PROCEDURE FOR INSPECTION OF EXISTING CONCRETE
EXPANSION ANCHORS IN RANGER INSTALLATION

DIABLO CANYON POWER PLANT (UNITS I & II)

SUBJECT EOI 1016
Diablo Canyon Power Plant Project
MADE BY Mike Gaur DATE 6/16/82 CHECKED BY MNP APPROVED BY _____

Robert L. Cloud Associates is concerned that the concrete anchor allowables on P.G. & E. drawing 054162 Rev. 3 do not agree with those on DEM-M9, Appendix C, Rev. 7; therefore, the correct design criteria for concrete anchor cannot be determined (See Appendix A). This documentation will address the difference between the two standards and will provide the safety factors represented in drawing 054162.

d. APPENDIX D

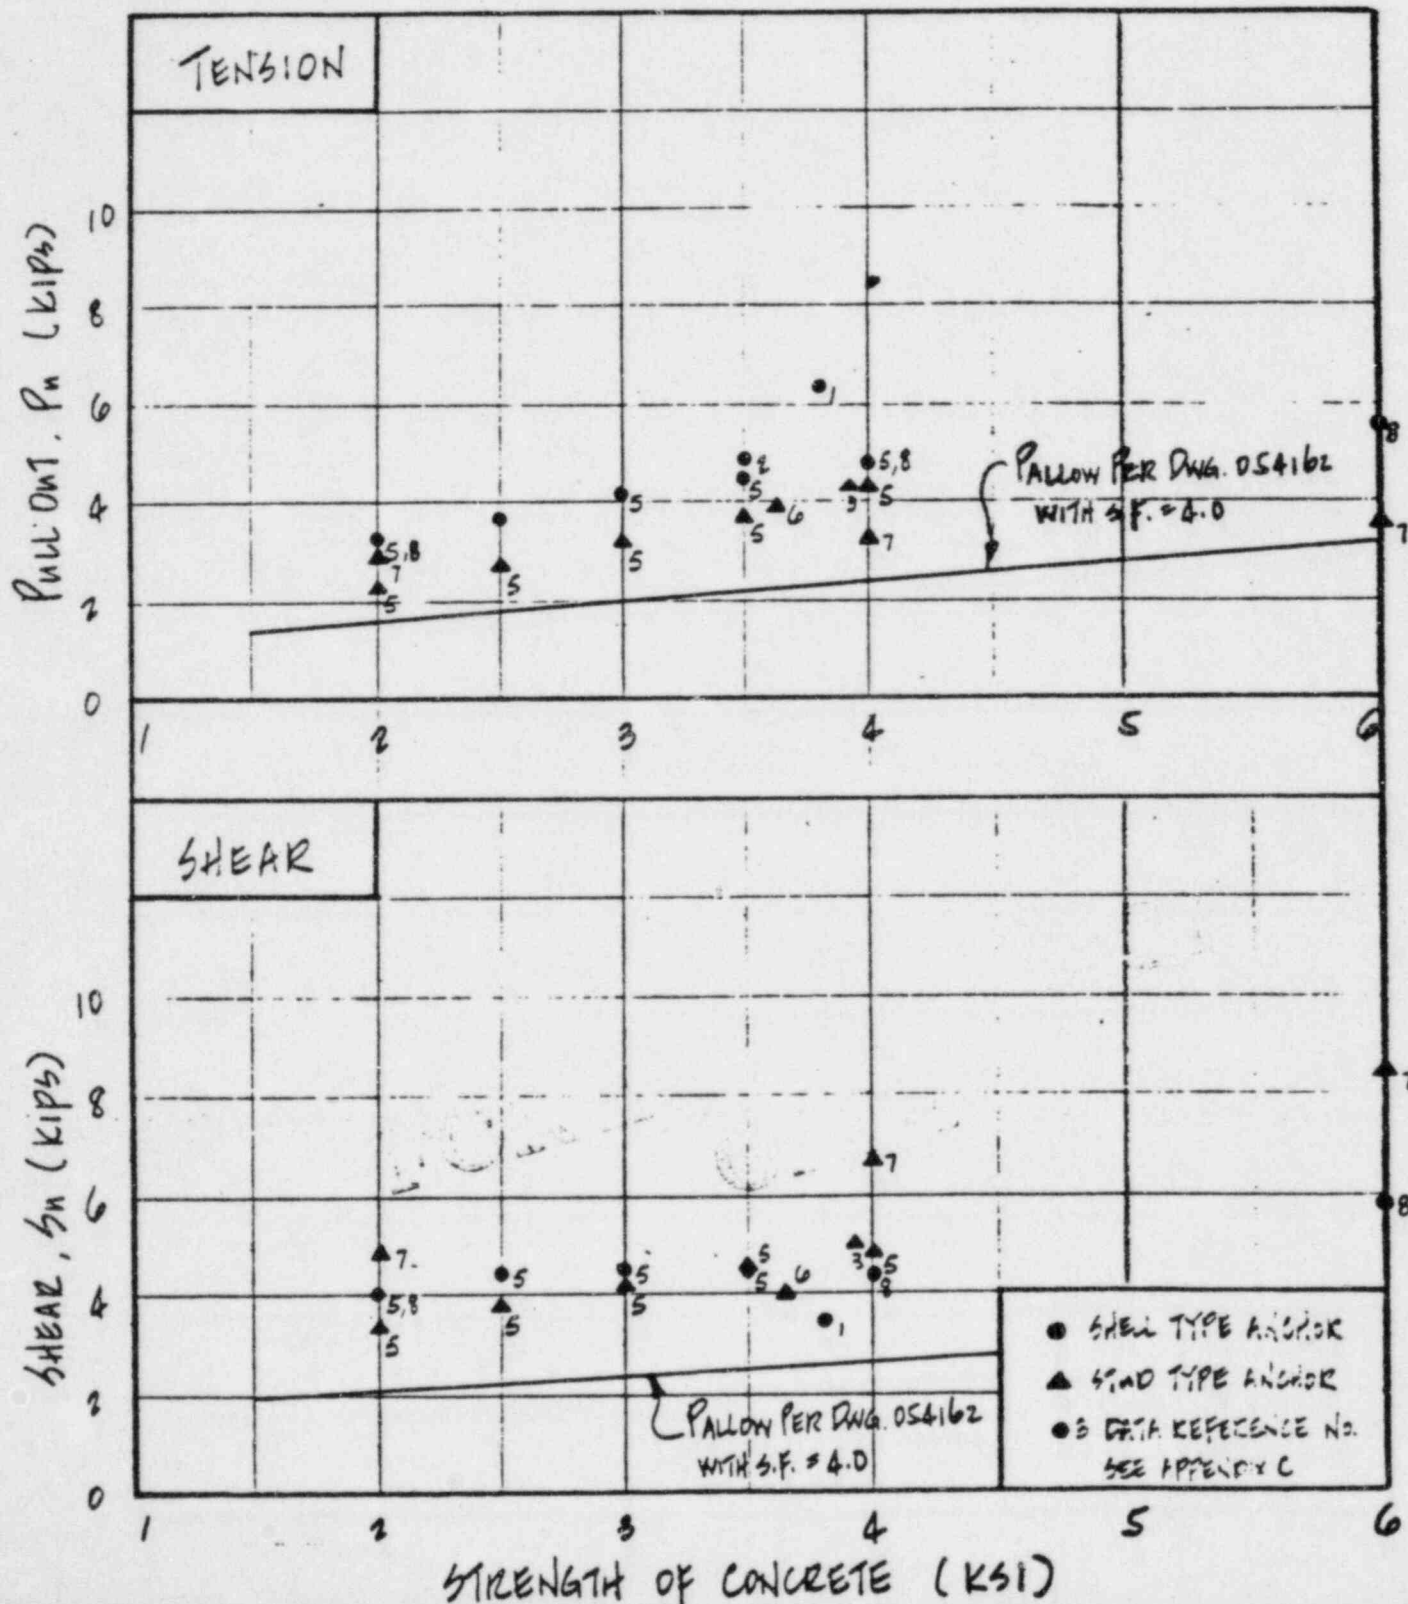
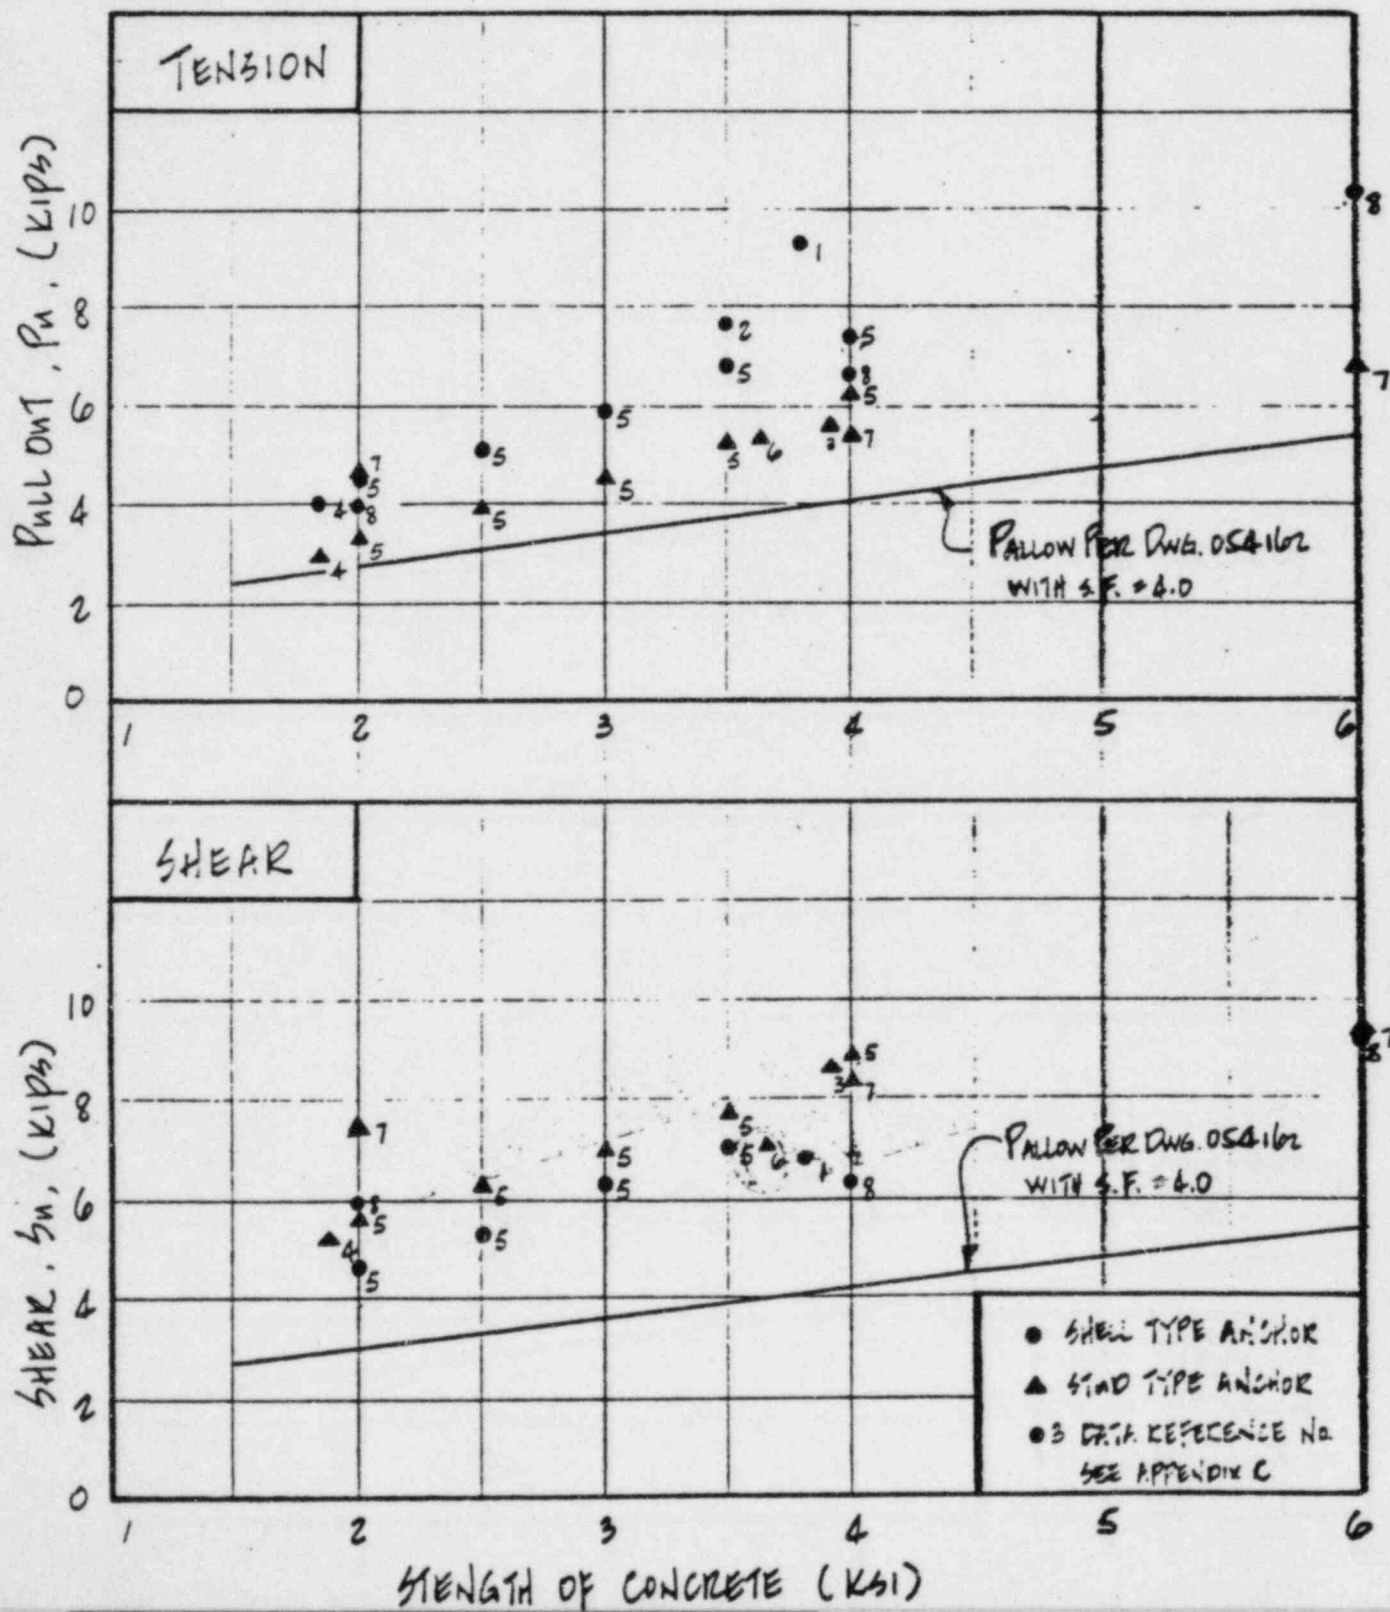
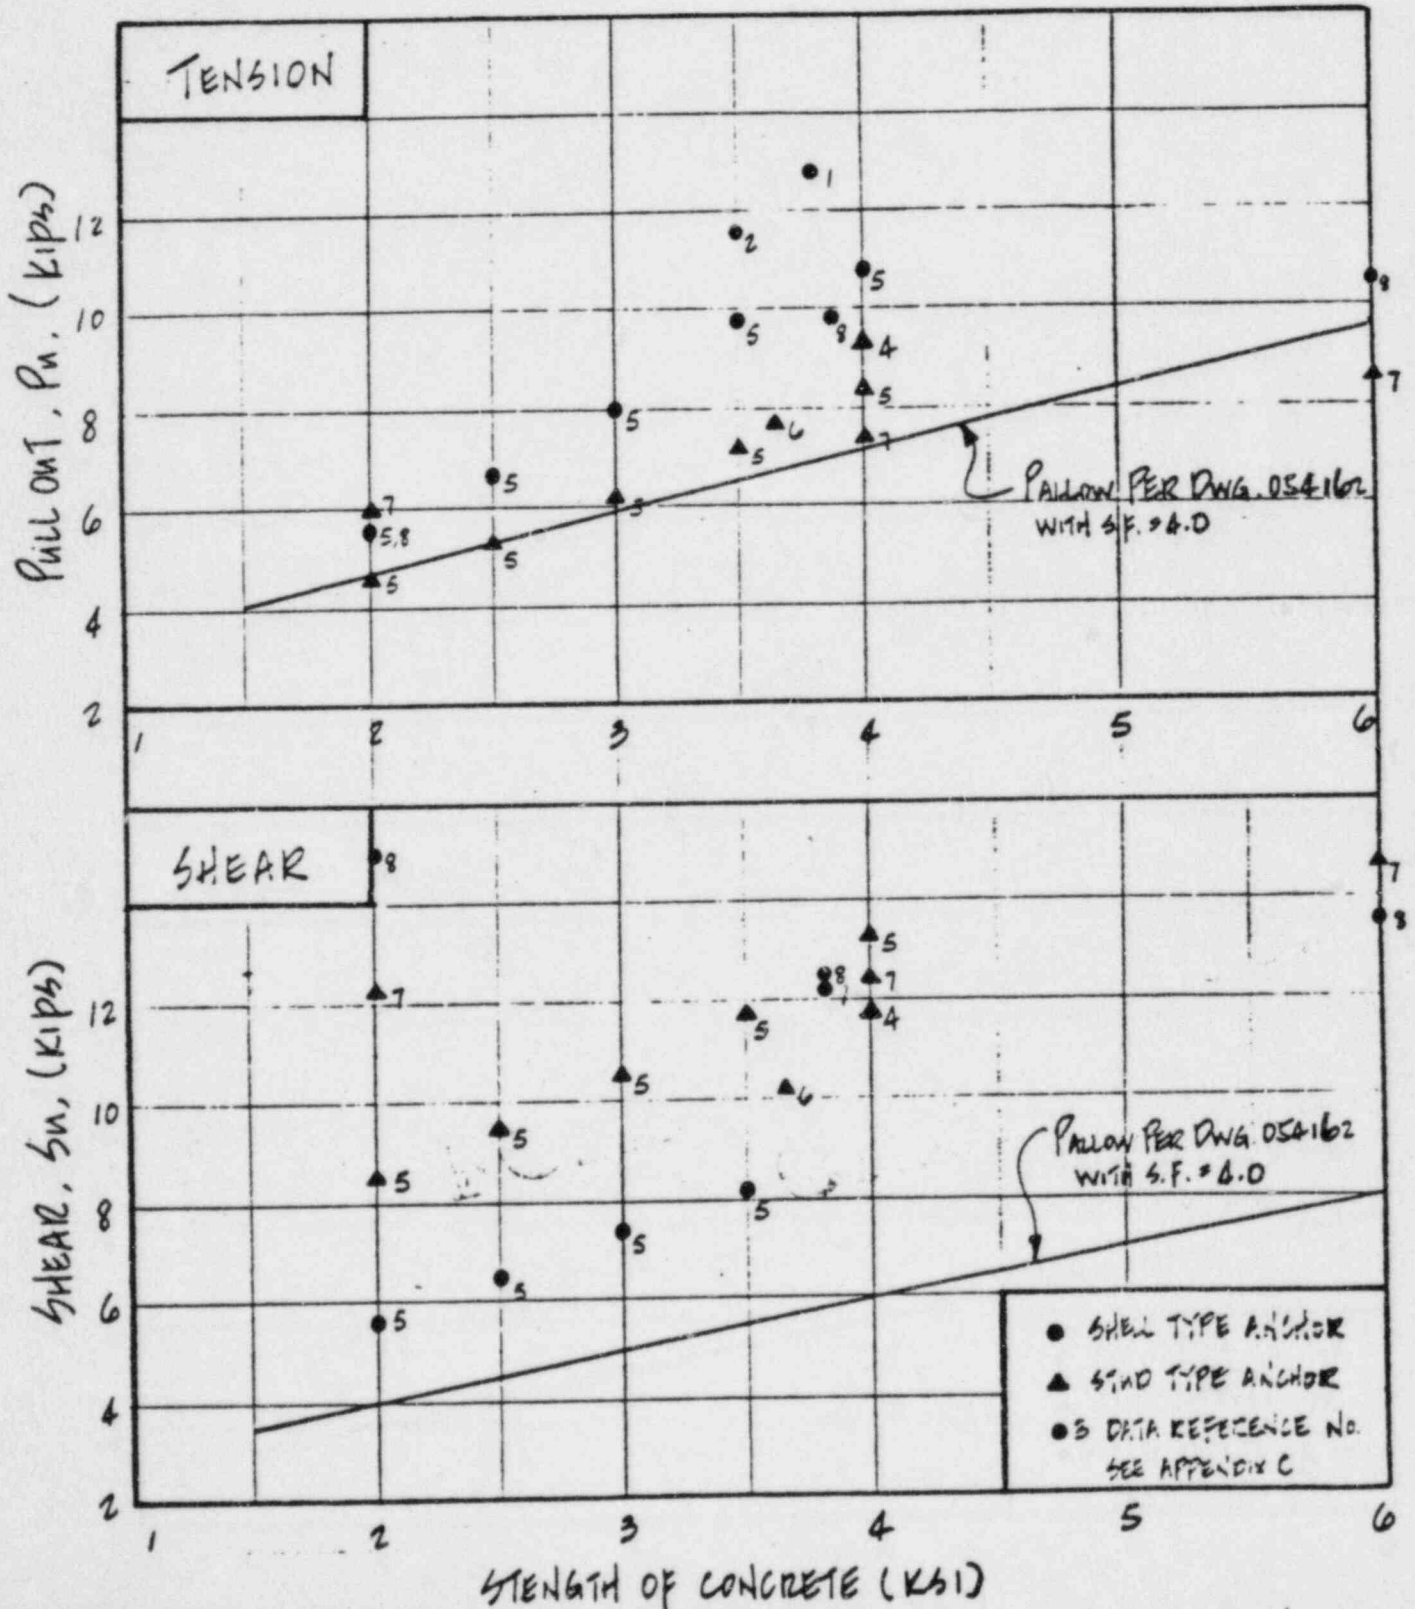
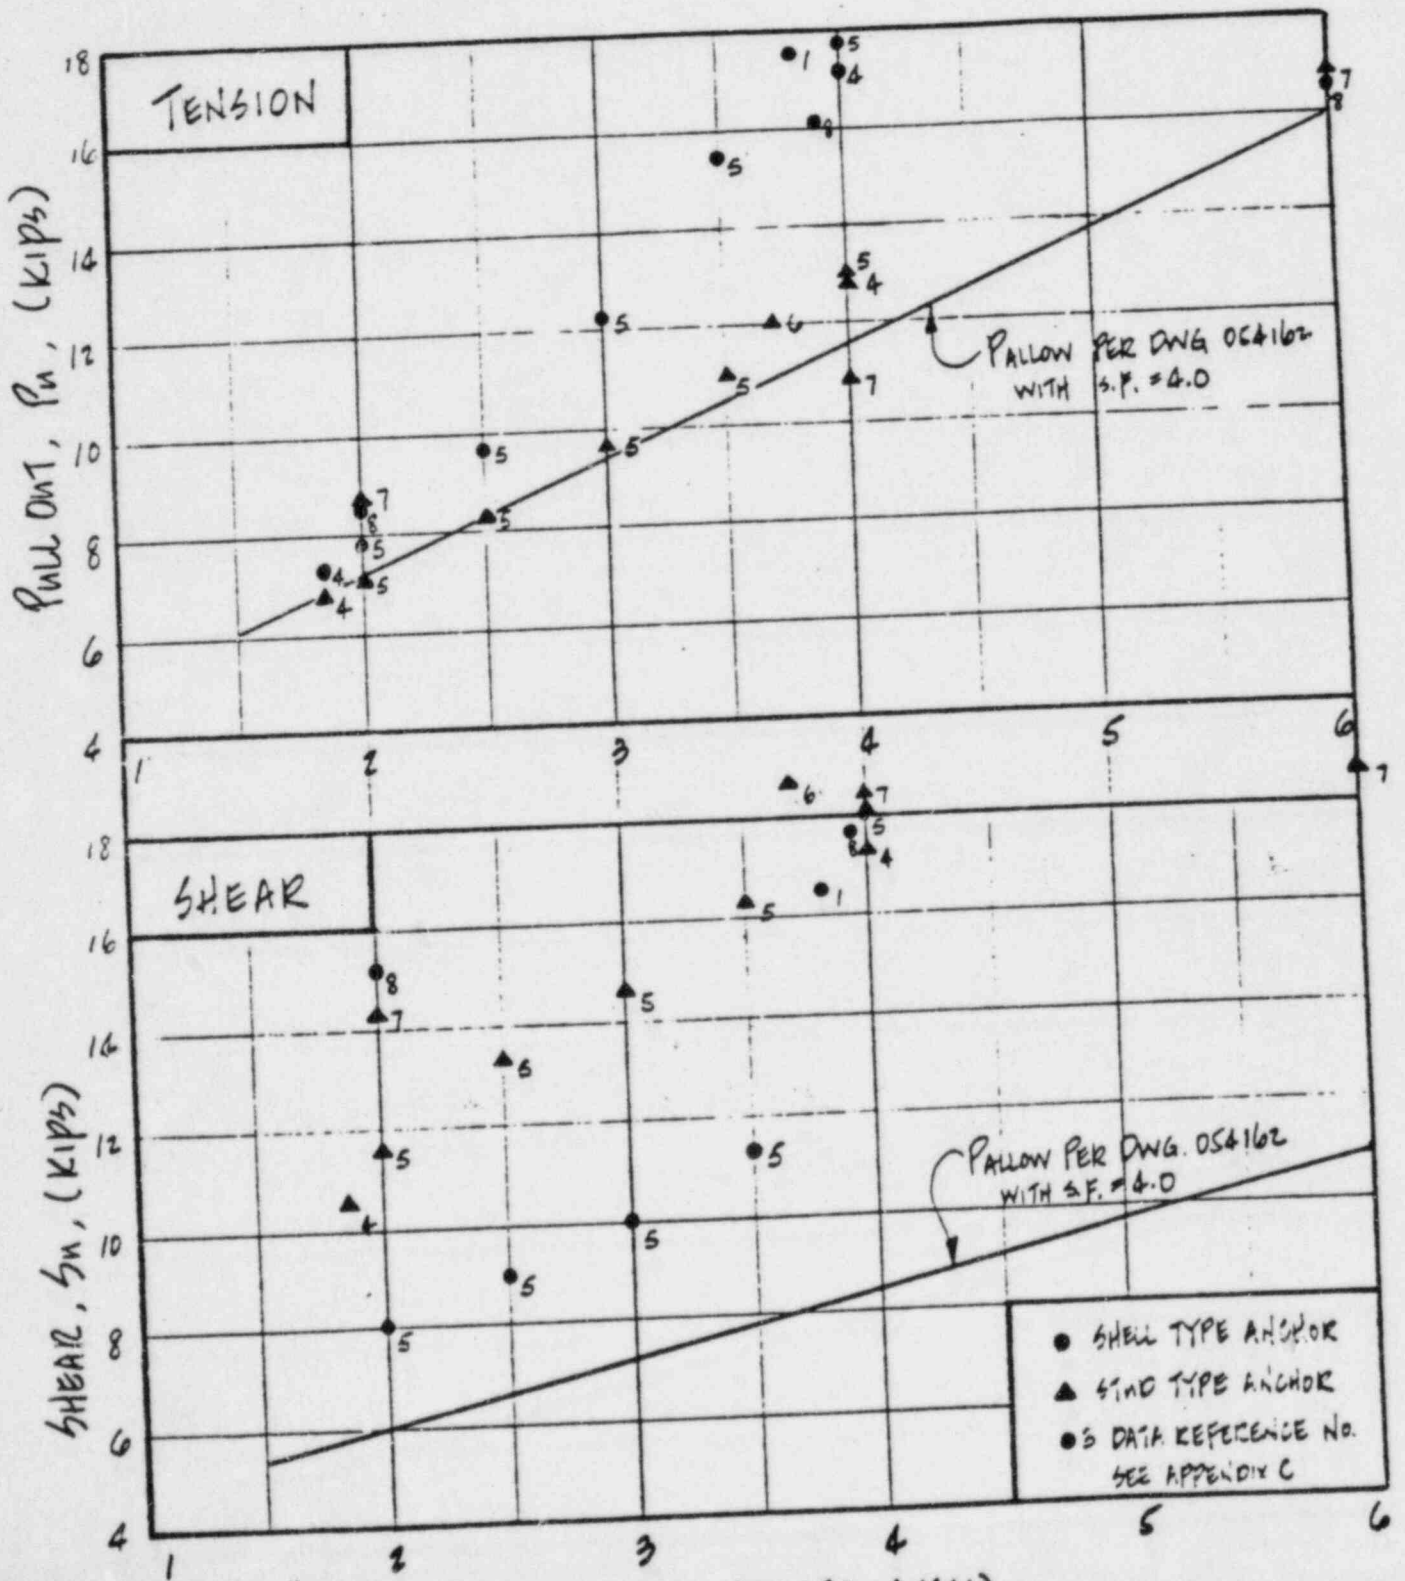
The anchor allowables on PGandE drawing 054162 Revision 3 do not agree with those on DCM-M9, Appendix C, Revision 7.

The correct design criteria for anchor bolts cannot be determined.

Please address EOI 1016 by listing the safety factors represented
in drawing 054162.

ANCHOR DIAMETER = $\boxed{\frac{1}{2}''}$

EMBEDMENT LENGTH = $\boxed{2\frac{1}{4}''}$

ANCHOR DIAMETER = $\boxed{5/8}$ EMBEDMENT LENGTH = $\boxed{27/8}$

ANCHOR DIAMETER = $\boxed{\frac{3}{4}''}$ EMBEDMENT LENGTH = $\boxed{3\frac{3}{8}''}$
